Addendum No. 1

Subject: Conwell Middle School Annex Fire Alarm Replacement: SDP Project No. B-064(c) of 2018/19

This Addendum, dated October 14, 2020, shall modify and become part of the Bid Documents. Any items not mentioned herein, or affected by, shall remain strictly in accordance with the original document.

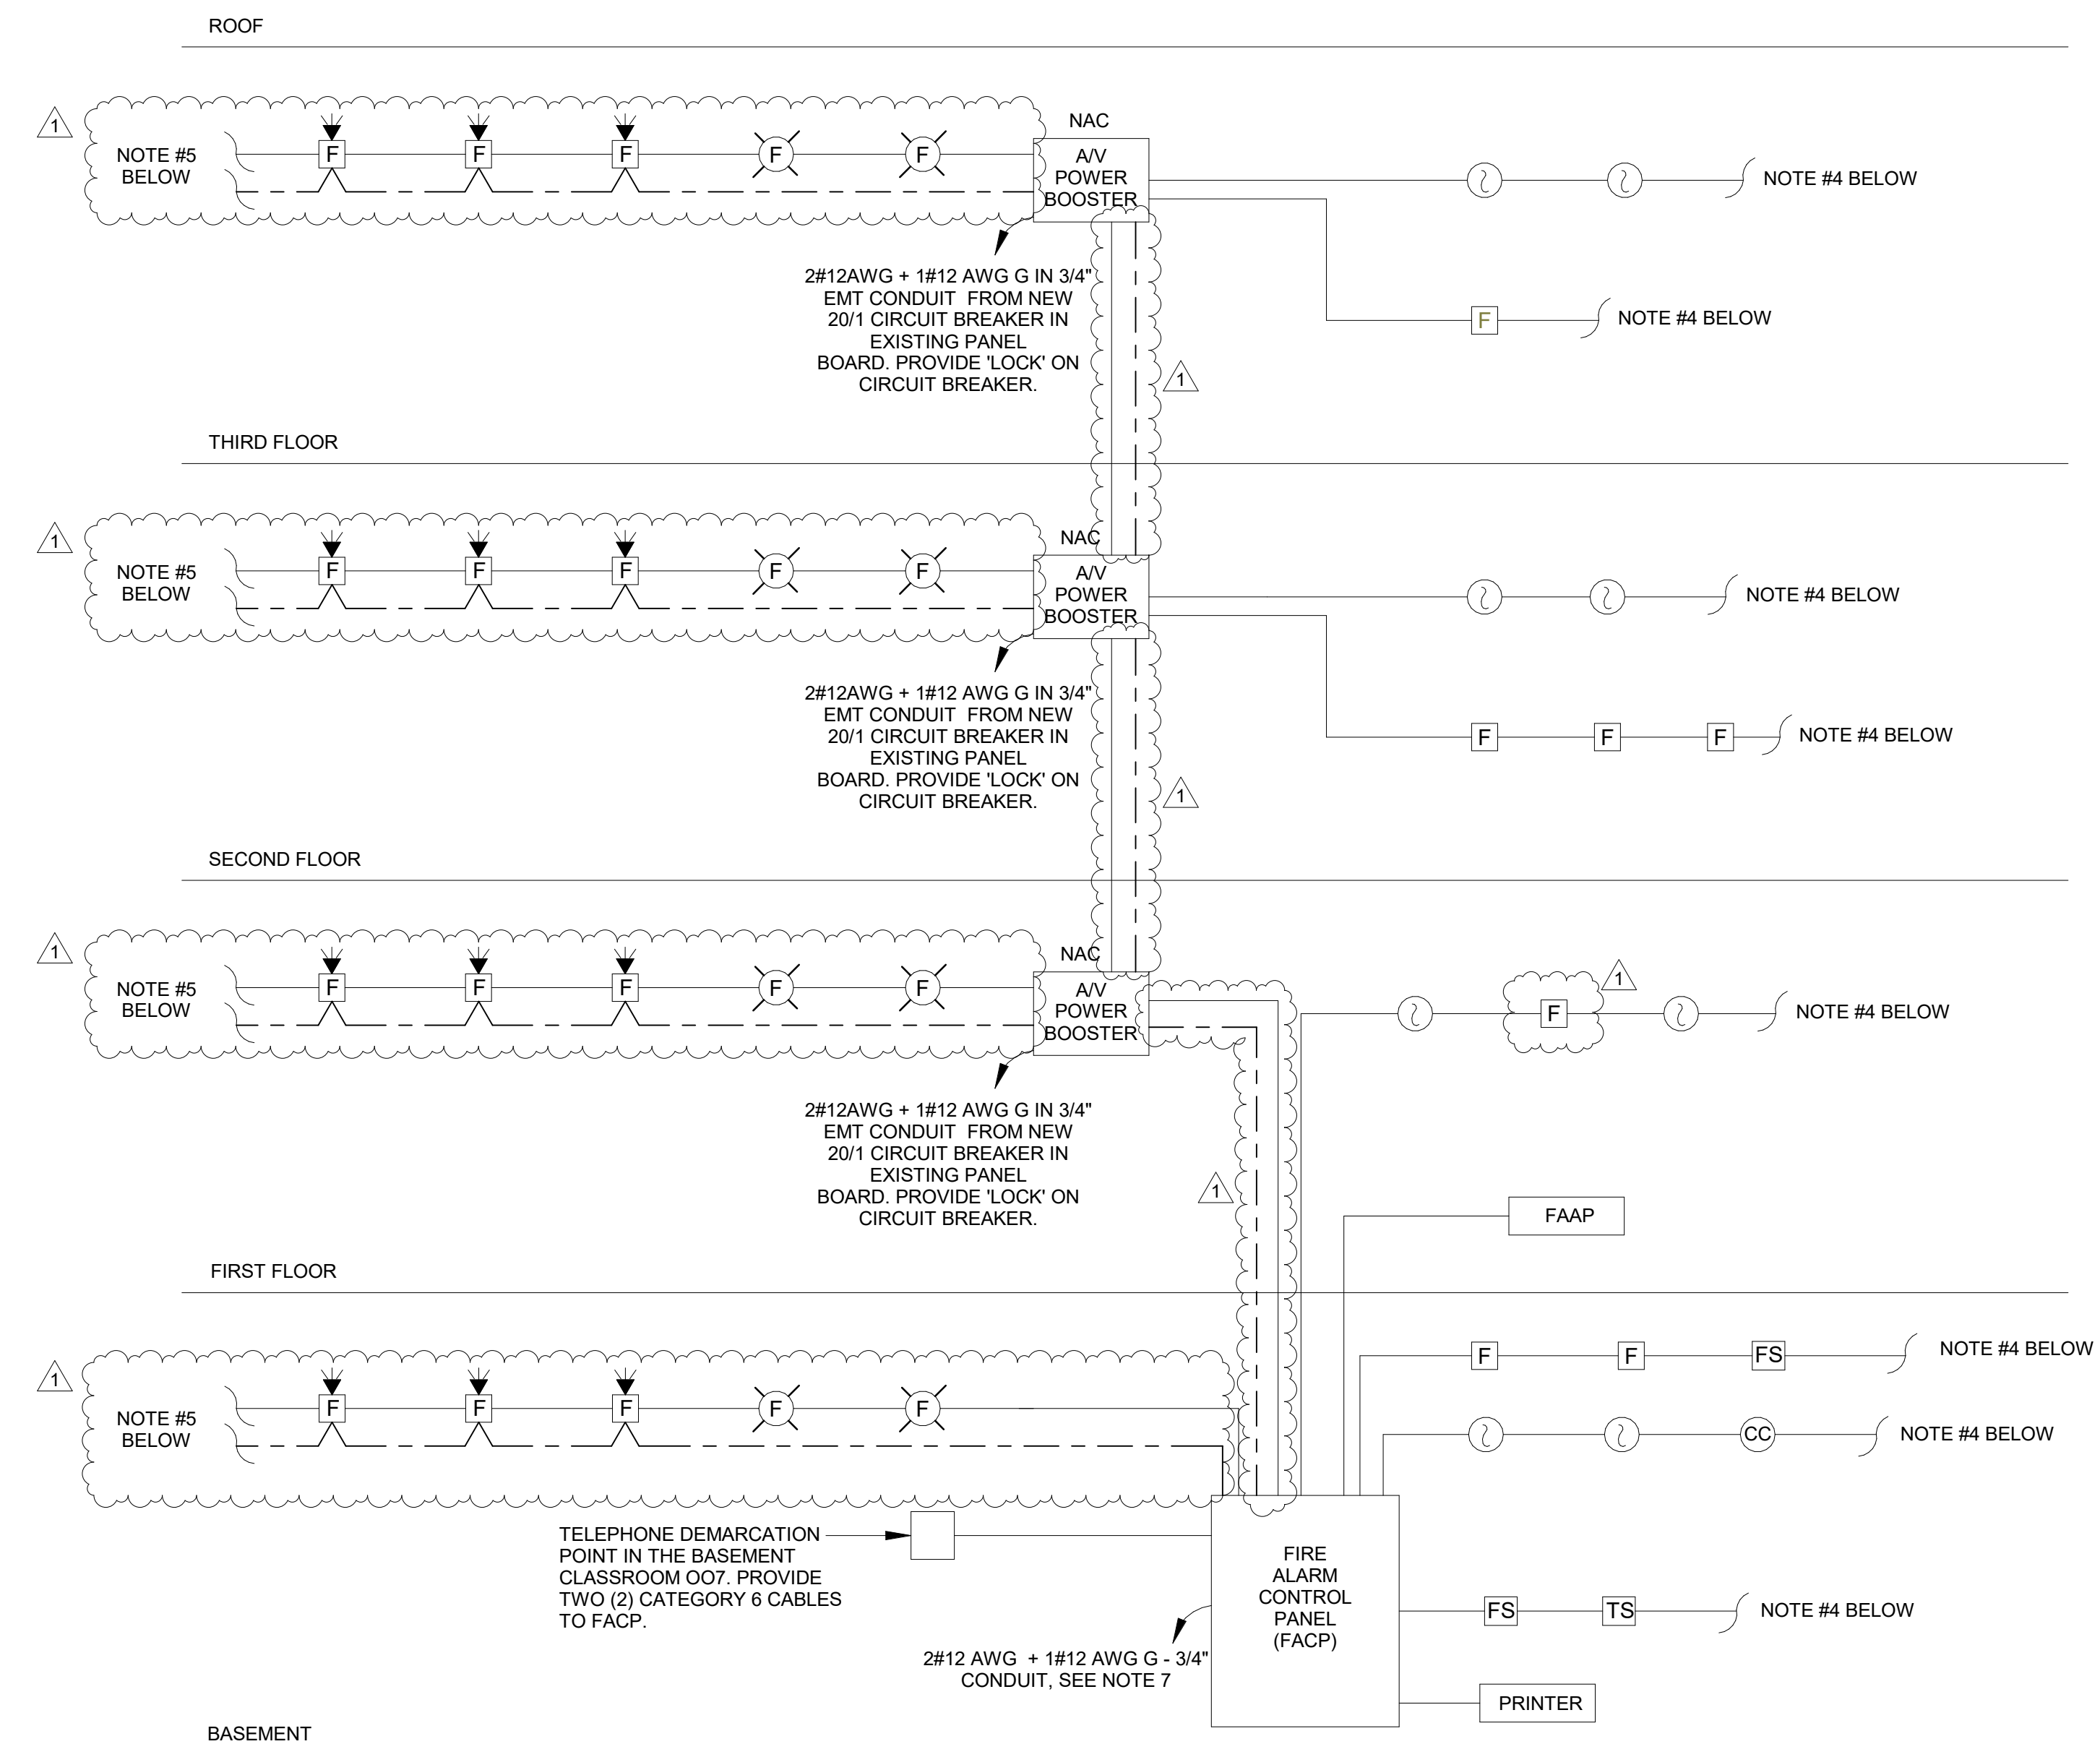
In reference to the (5) different heat detectors listed in the extra materials list on DWG E-001 and in the specs, please clarify what type of heat detector is shown on the plans. The symbols list only describes the symbols as "heat detector".

All heat detectors shall be 135-degree fixed temperature with 15-degree rate of rise.
